**STAFF REPORT:** 4/14/2021 MEETING  
**APPLICATION NUMBER:** #21-7154  
**ADDRESS:** 2489 ATKINSON  
**HISTORIC DISTRICT:** ATKINSON AVENUE  
**APPLICANT:** JOHN MCCARTER  
**PROPERTY OWNER:** ANNE CALAHAN  
**DATE OF PROVISIONALLY COMPLETE APPLICATION:** 03/05/2021  
**DATE OF STAFF SITE VISIT:** 3/24/2021

**SCOPE:** SOFFIT, SIDING, FASCIA, & TRIM REPLACEMENT – WORK DONE WITHOUT APPROVAL

Site Photo 2 by Applicant: (South) side/rear, work complete.

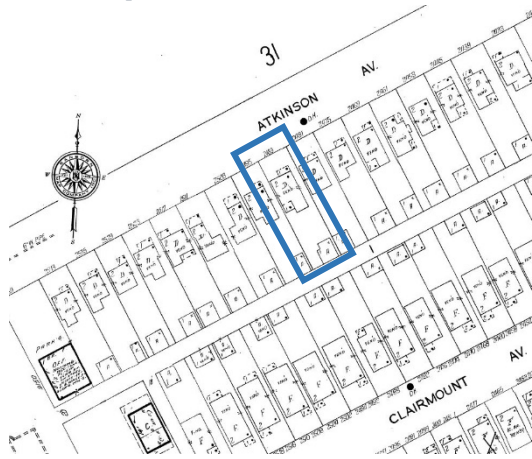
- It is staff’s opinion that the original cedar shake siding on the second floor is a character-defining feature of the house and therefore the pine lap siding is not an appropriate use of material for replacement of the cedar shake siding.

- From the older photo (see above) it appears that the original trim for the side of windows is 2” at the base and sill, but 4” at the mullion (separation between the two windows). It is staff’s opinion while the pine trim is an appropriate material, but the increase in the trim’s width from 2” to 4” all around both sets of windows is not an appropriate size for the existing context of these windows.

Because the cedar shake expression at the rear second story is a distinctive character-defining feature, it should not be replaced with horizontal lapped siding. Staff therefore recommends that the Commission issue a Denial for this proposal as it does not meet the Secretary of the Interior's Standards for Rehabilitation, specifically Standards:

- The applicant will provide dimensions and specifications to replace window trim for HDC staff review and approval prior to an issued permit.
- The applicant shall provide a paint color to HDC staff that meets Color System C color guidelines for the rear siding and trim.
